Re: Rapiscan AIT System Radiation Survey Reporting

R-0646-1 Addendum (Documentation Errors)

| Product Name | Secure 1000SP (Single Pose) |
| Serial Number | S51023004 |

1. In Beam Dose Measurement: Survey Table. 1

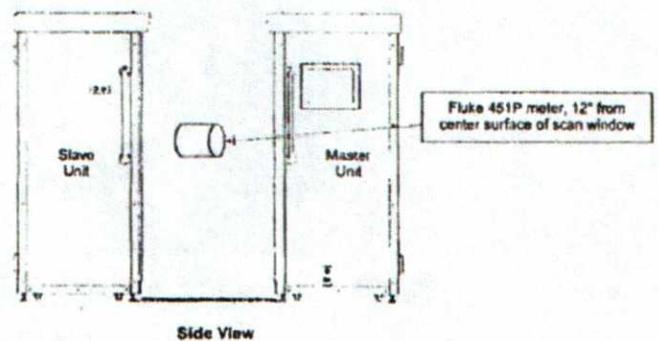
1. No value indicated for background radiation. Typical values range from 7uRem/hr to 13uRem/hr at sea level. Note: Absence of value has no adverse impact on calculations.
2. Technician did not indicate scan time. Correct scan time is 3 seconds.
3. Technician did not indicate where system was manufactured.
4. TABLE 1: Incorrect presentation of data in Column 3 for Measured Exposure. Indicated values are 23uR and 26uR. Corrected values are 2.3uR and 2.6uR. The values were corrected by technician when calculating Effective Dose.
5. Technician did not print his name on survey report.
6. Technician did not initial pass or fail check box.

The service technician should attend refresher training.

The corrected data indicates this system was operating within expected parameters. No re-survey is required for this system.
